**Addendum No. 3**

**Final Environmental Impact Report  
for Metro Gold Line Foothill Extension - Azusa  
to Montclair (SCH 2010121069)**

**Evaluating Minor Design Changes of the Project  
Azusa to Montclair**

Metro Gold Line Foothill Extension Construction Authority  
March 2016

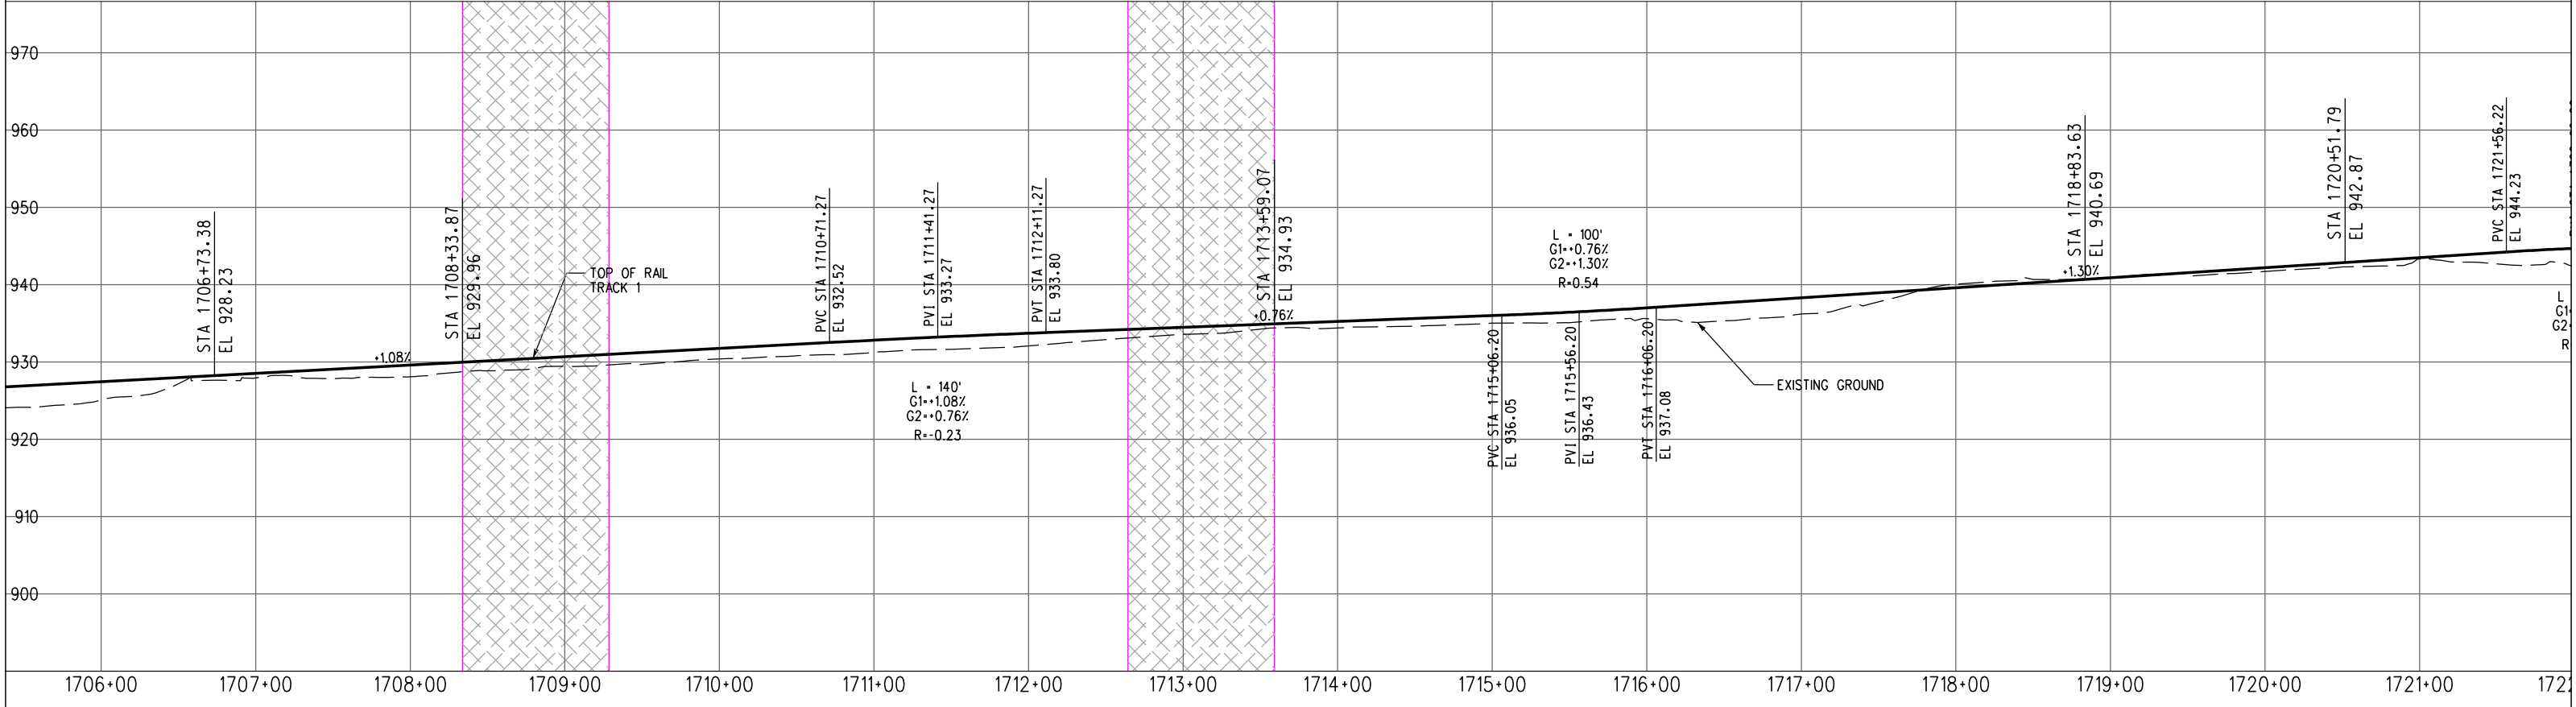
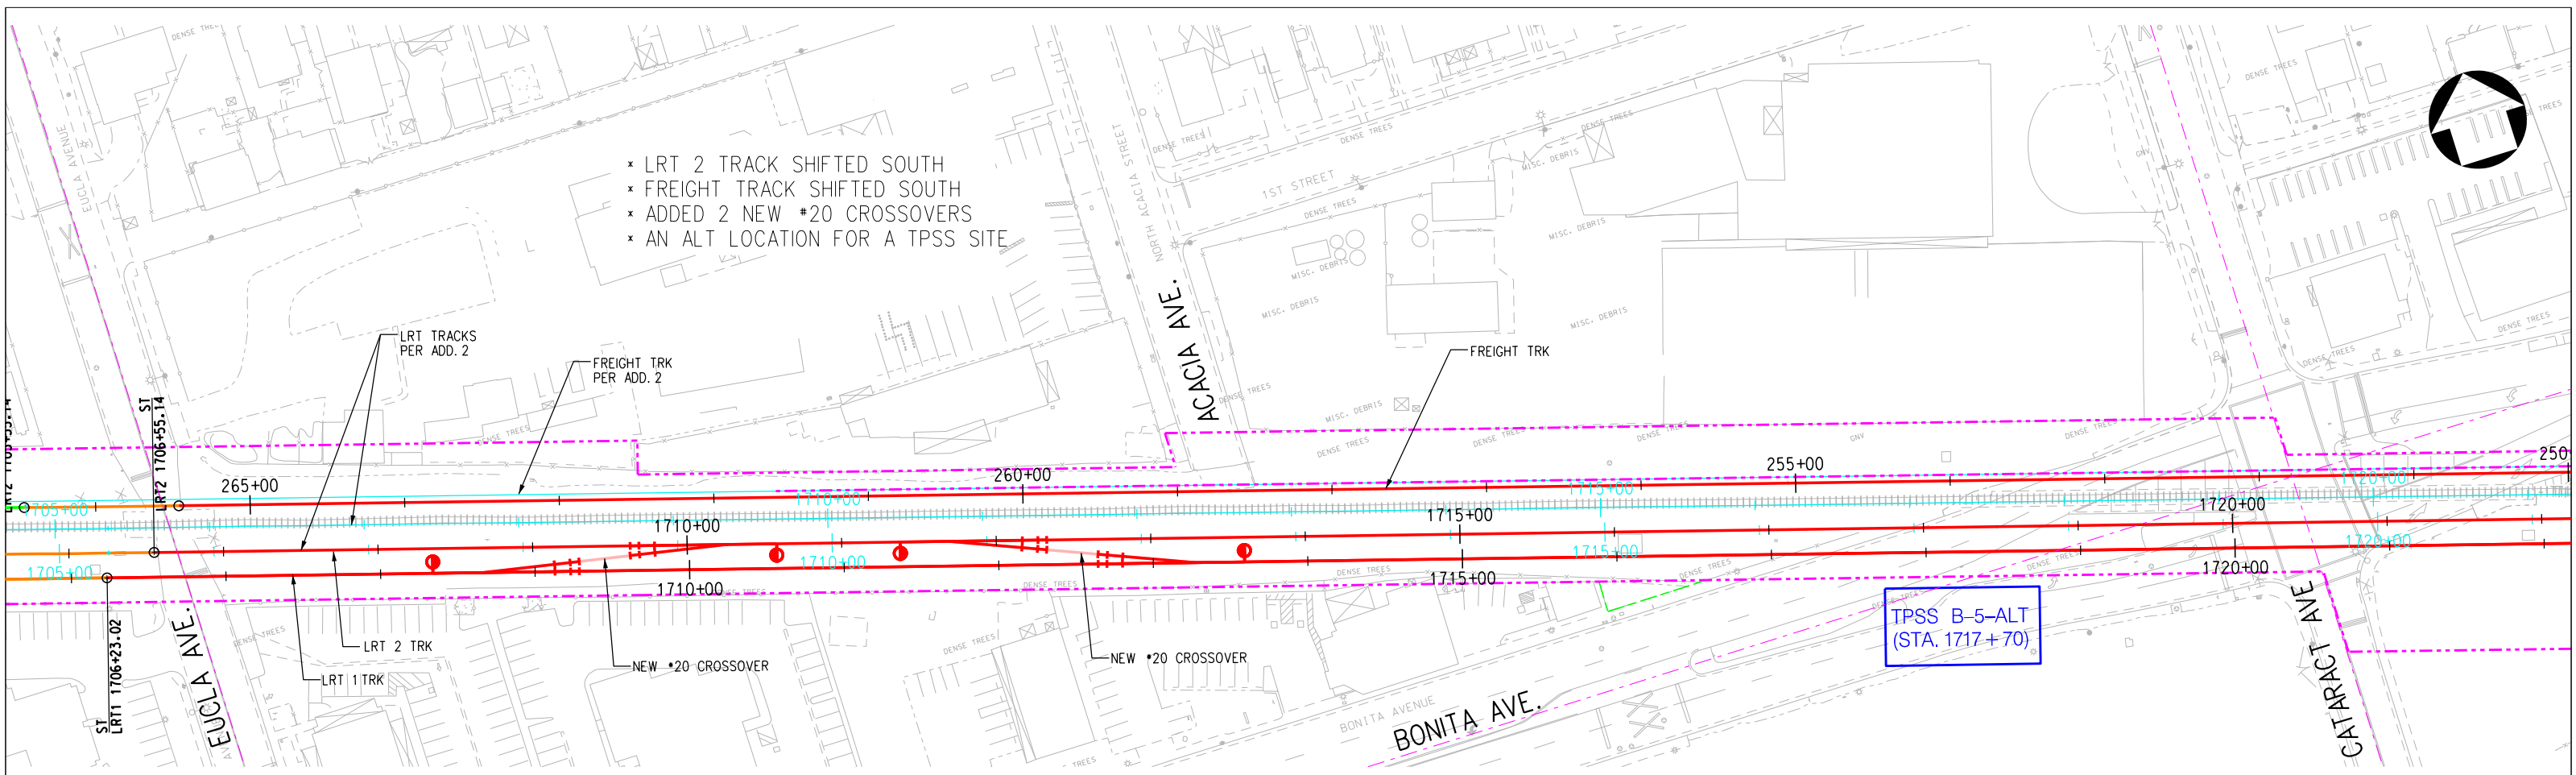
- \* LRT 2 TRACK SHIFTED SOUTH
- \* FREIGHT TRK SHIFTED SOUTH
- \* ADDED 2 NEW #20 CROSSOVERS
- \* AN ALT LOCATION FOR A TPSS SITE

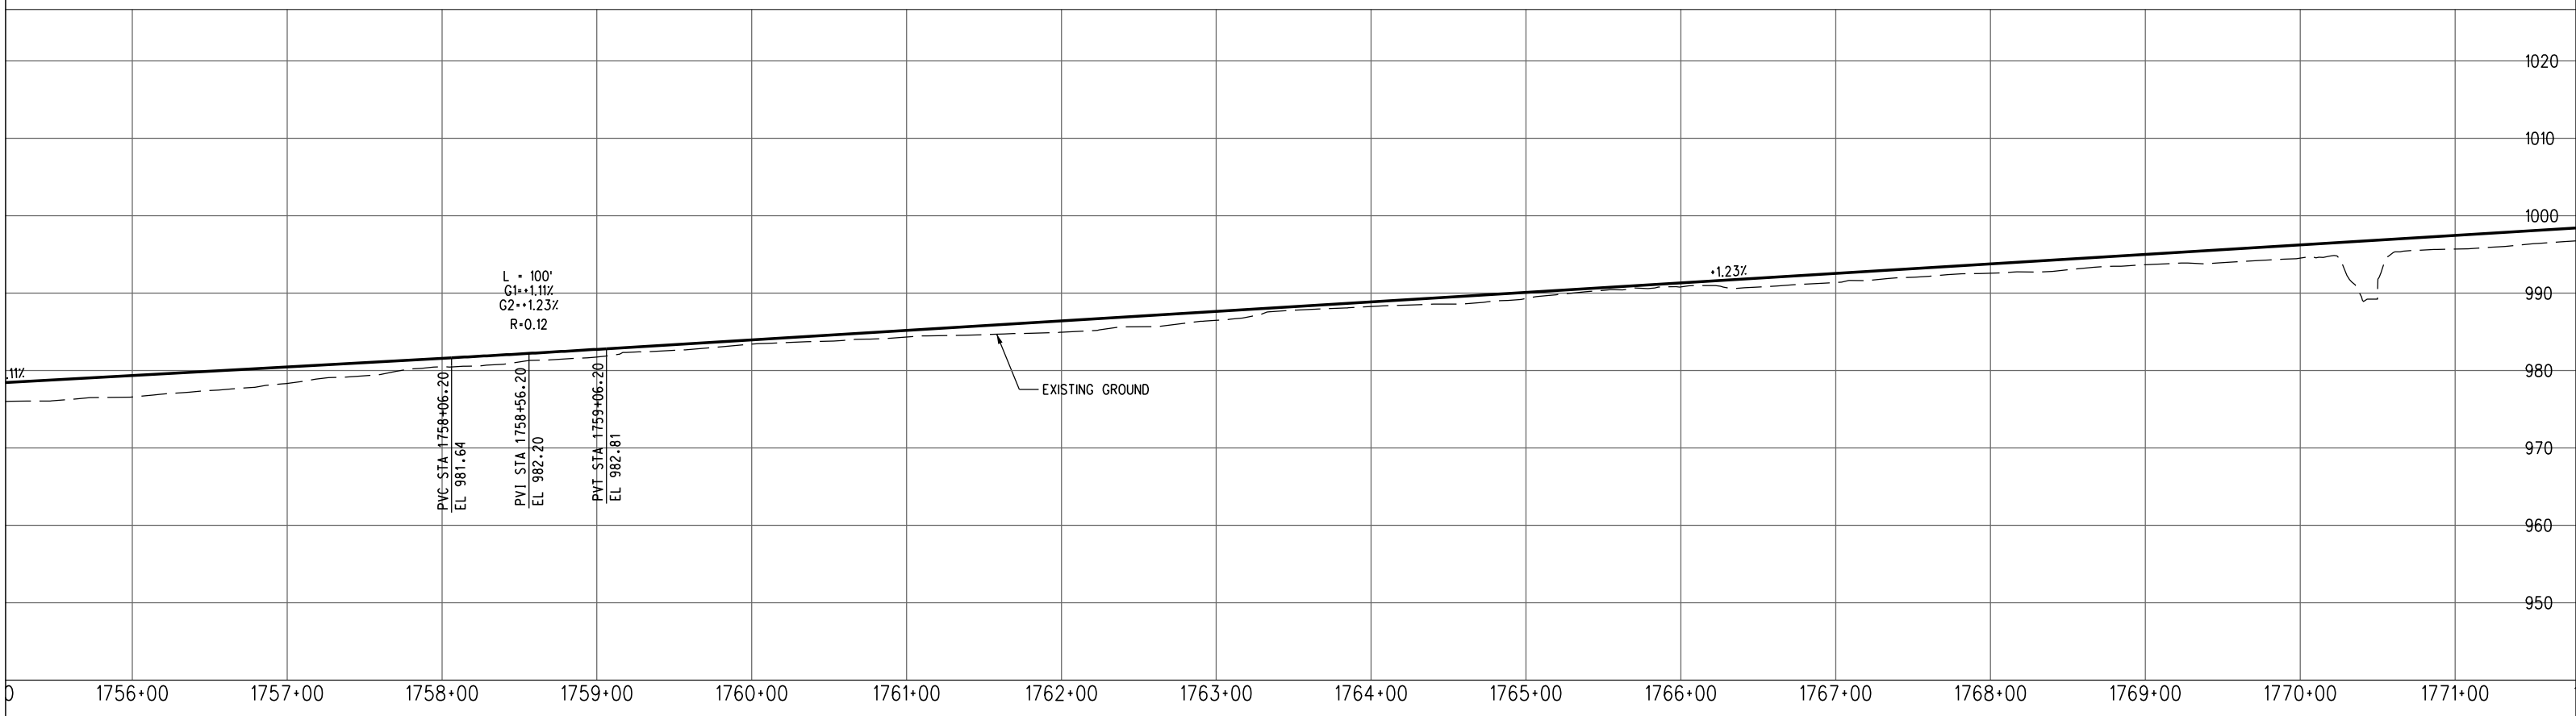
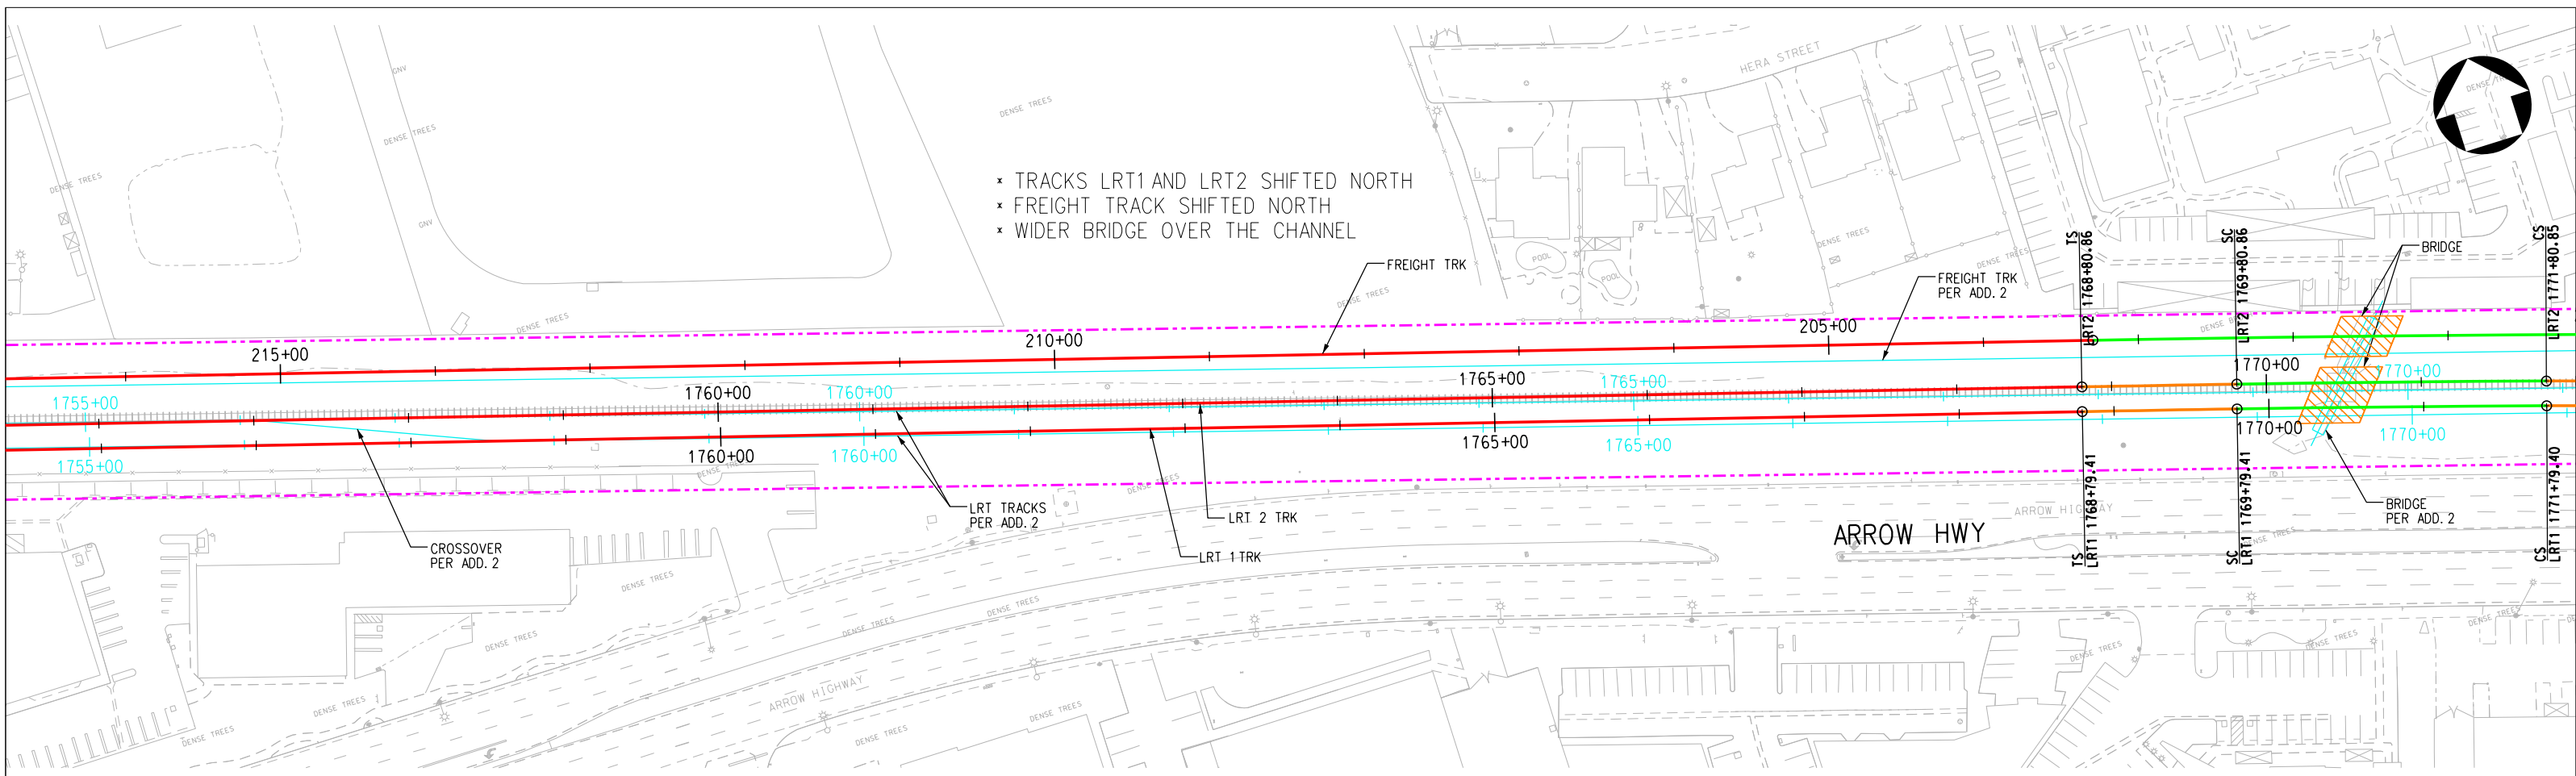
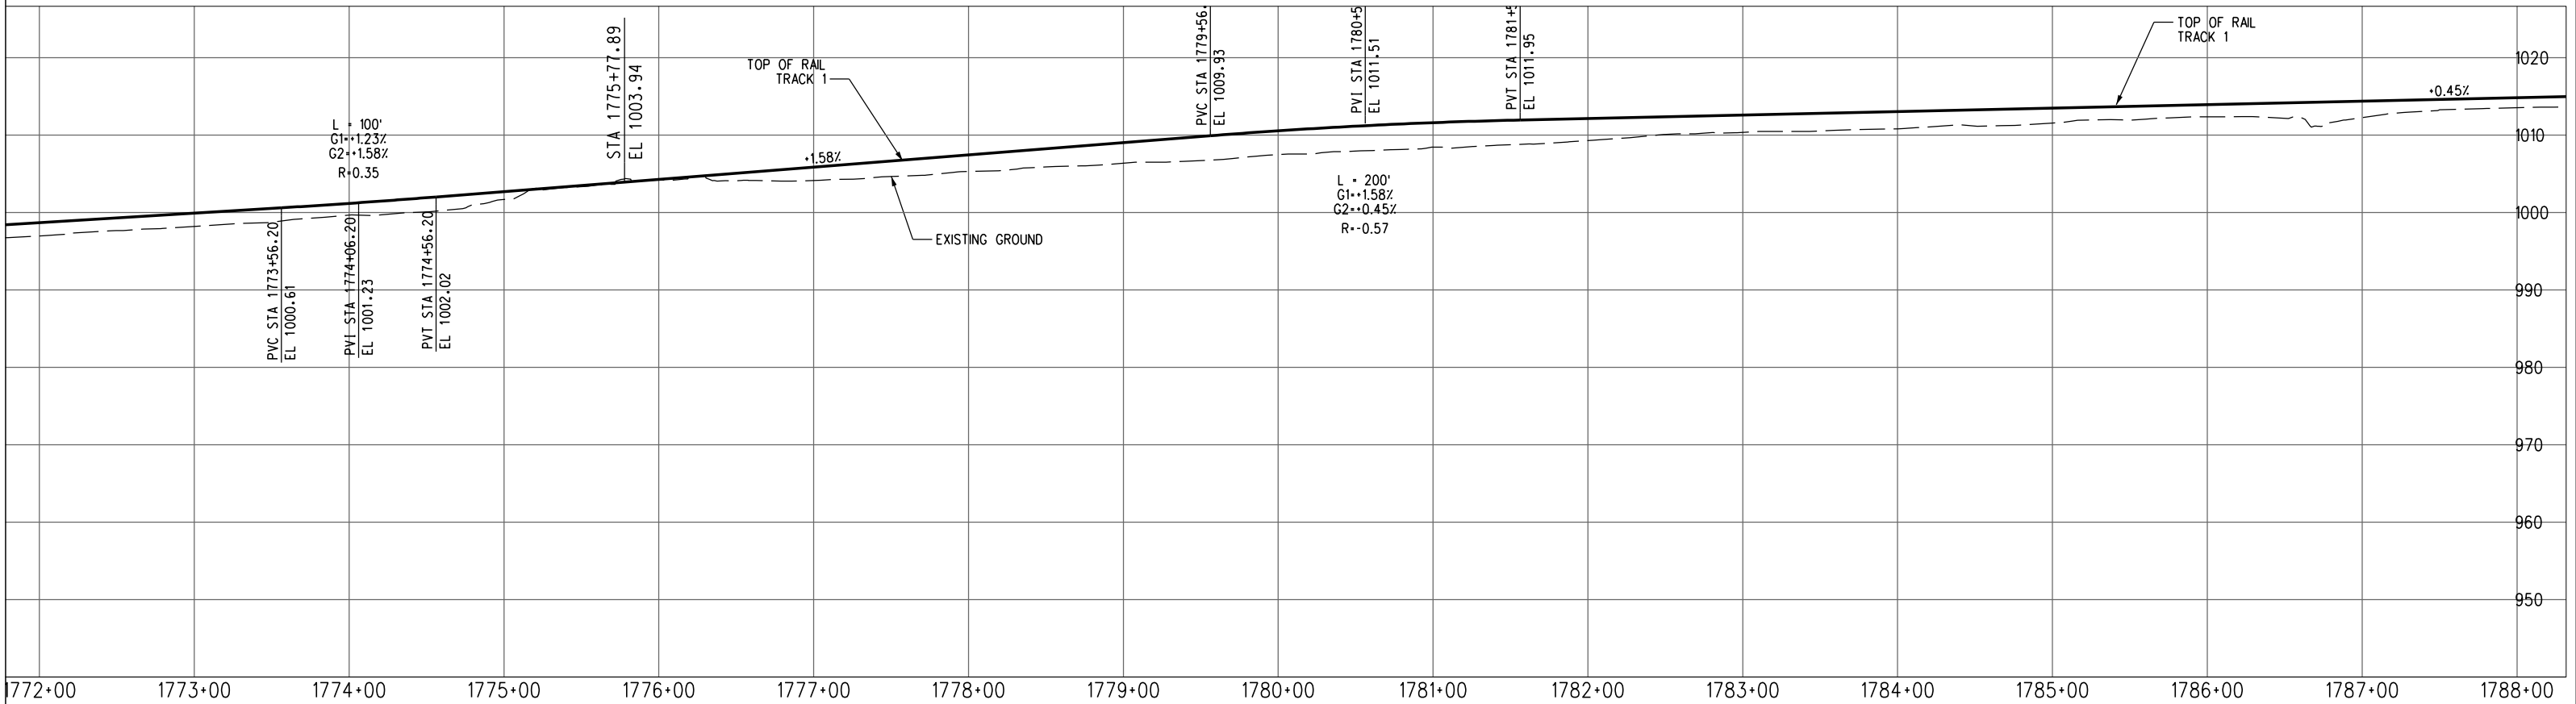
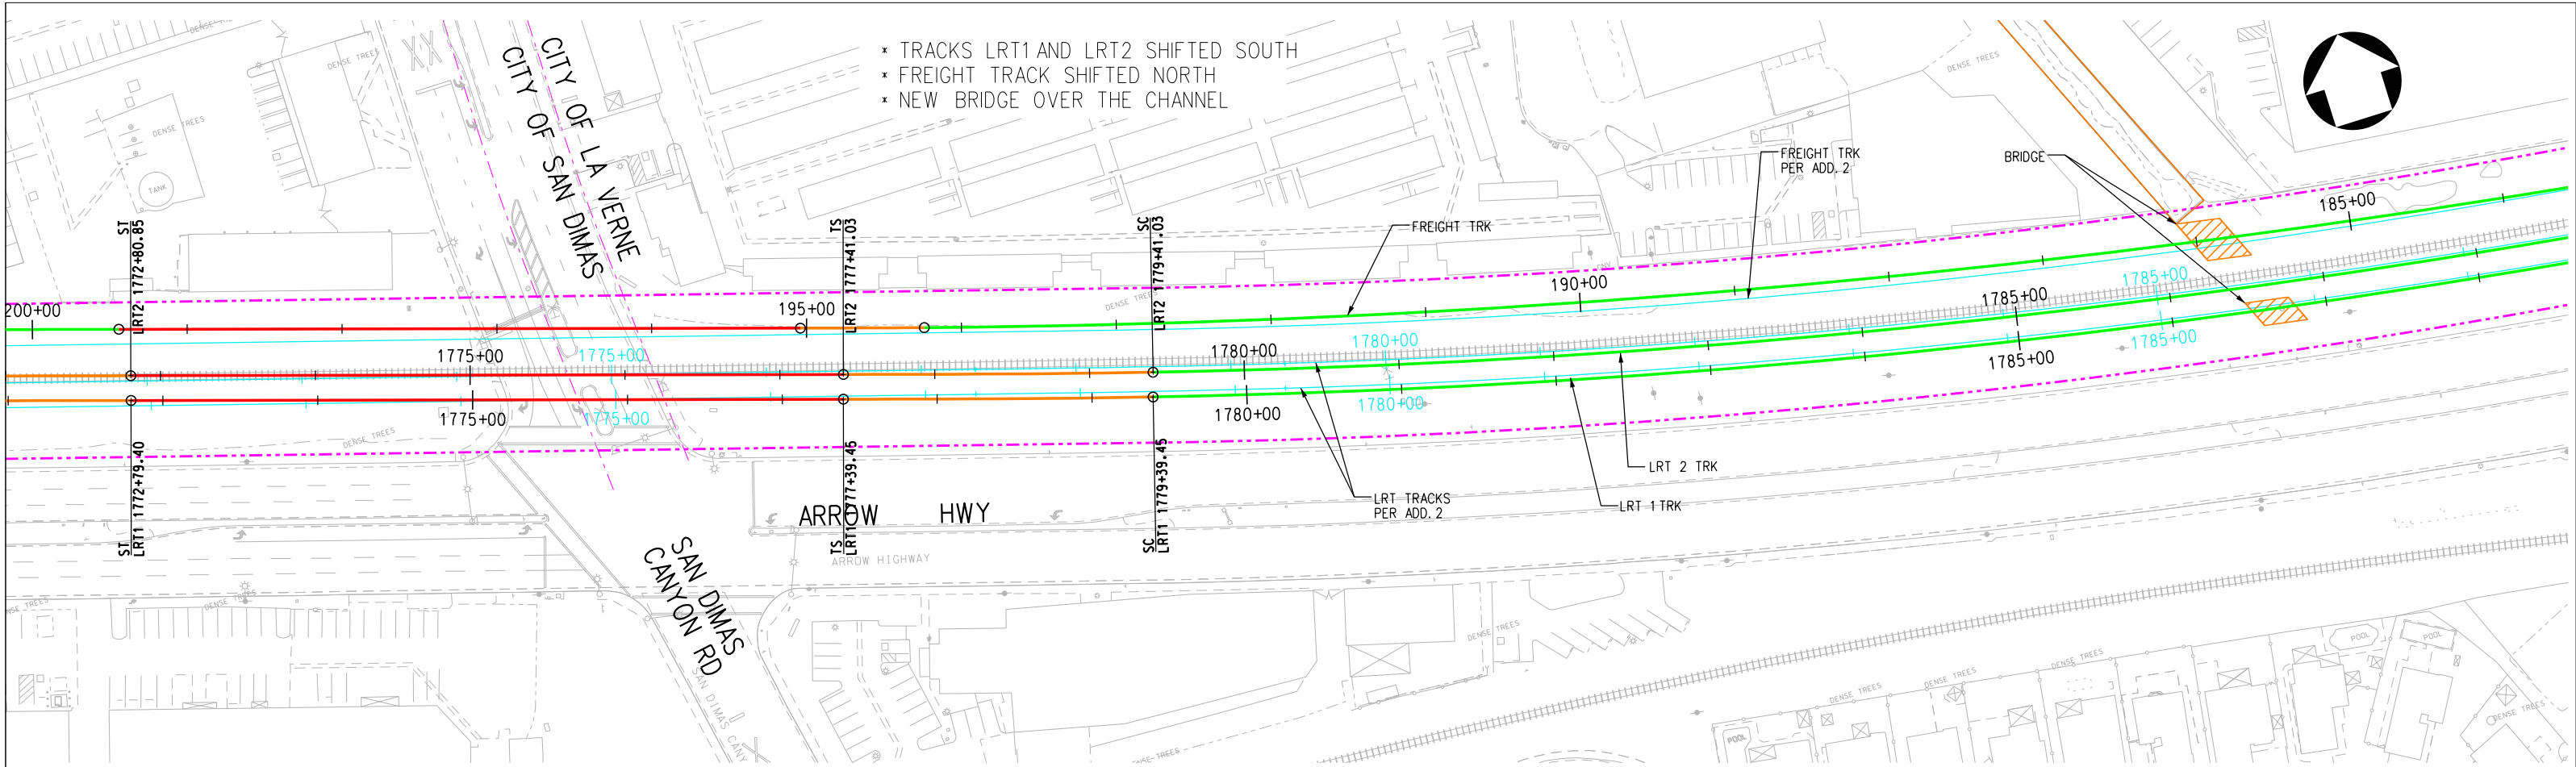
- \* TRACKS LRT1 AND LRT2 SHIFTED SOUTH
- \* TPSS SITE SHIFTED SLIGHTLY SOUTH
- \* PLATFORM SHIFTED
